Application Number: 09/785,026 Filing Date: February 15, 2001 Appellant(s): Yoshihide ITEYA

## **EXAMINER'S ANSWER**

This is in response to the appeal brief filed April 25, 2006 appealing from the Office action mailed May 27, 2005.

FIG. 10

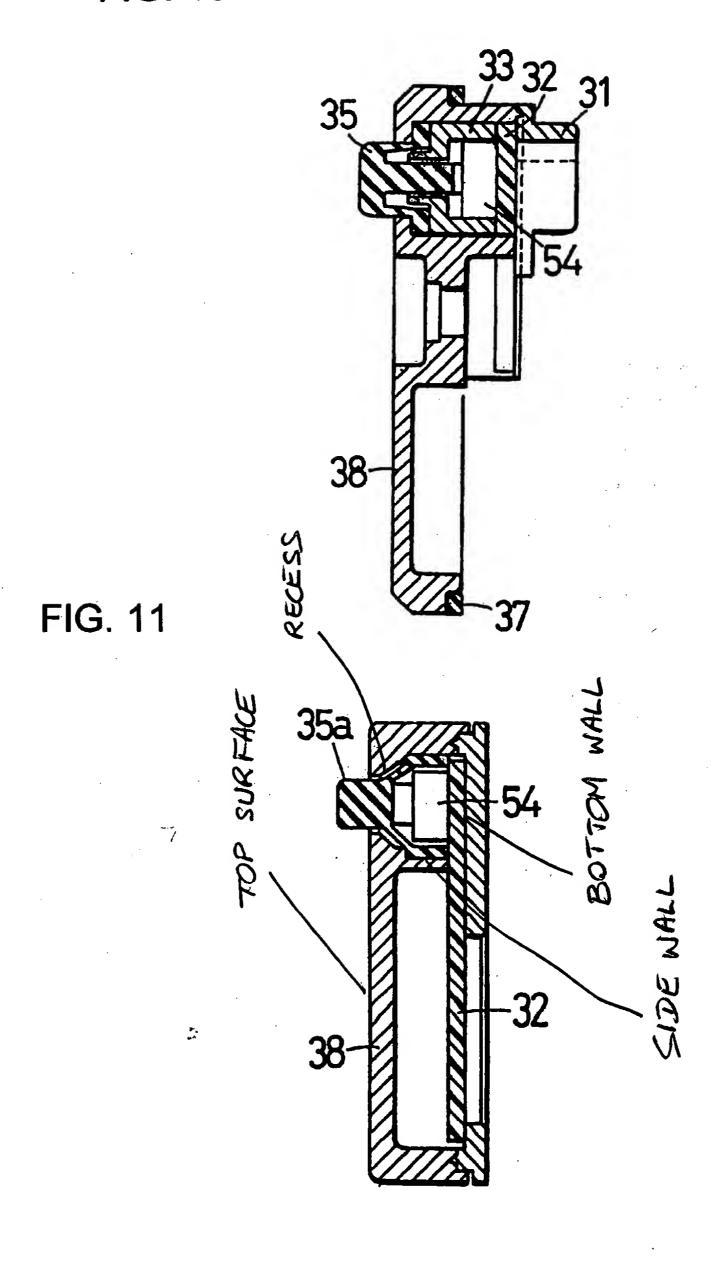
Appellant averred that Abe does not teach the handlebar assembly comprising a bicycle control device that has a top surface defining a switch mounting recess therein, the recess having bottom and side walls. This contention is unsupported by Figs. 1 and 11 of Abe as explained above.

FIG 2

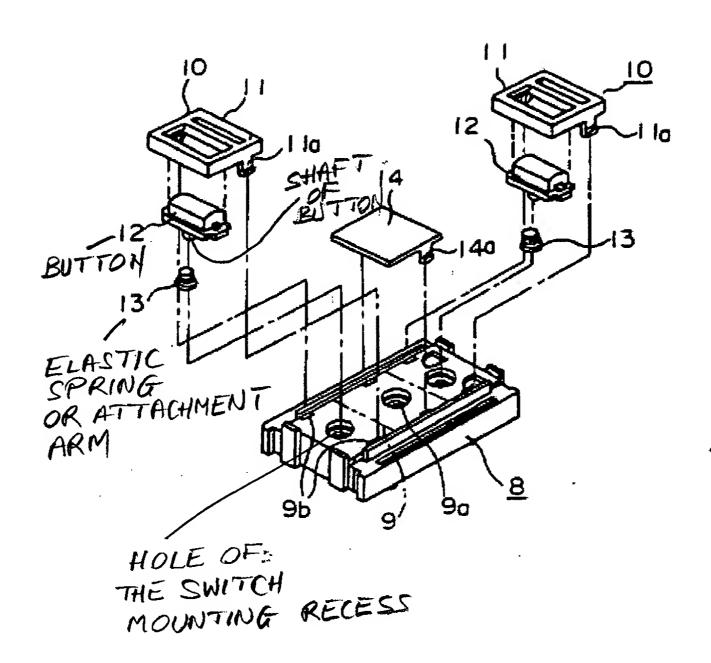
In this case, Fig. 2 of Miyoshi shows that the spring 13 is: (a) attached to the button 12; (b) made of an elastic material; and (c) is press fitted into the hole (unnumbered in Fig. 2. See Attachment 2) of the switch mounting recess (Att. 2) as described on page 4 of the translation. Appellant argued on page 21 of the brief that "[t]here is no recess having a bottom wall that defines a hole." However, this argument is likewise unsupported by substantial evidence. Appellant overlooked the fact that Figs. 2-4 of Miyoshi show that: (a) the spring/arm 13 is fitted into the hole (Att. 2) as seen by the assembly lines in Fig. 2; and (b) the cover 8 in turn is connected to the base 7 as seen in Fig. 3 or 4. Therefore, the bottom wall of the base 7 is the bottom wall of the hole of the switch mounting recess. The hole/recess as shown in Att. 2 conforms to the shape of the shaft of the button 12 so that the button 12 can be assembled to the hole as evidenced by the assembly lines in Fig. 2. Put in another fashion, Miyoshi teaches or suggests the limitation "the operation control button having an attachment arm made of an elastic material, wherein the attachment arm is press fitted into the hole of the switch mounting recess" in claim 8 or 22 via Figs. 2-4.
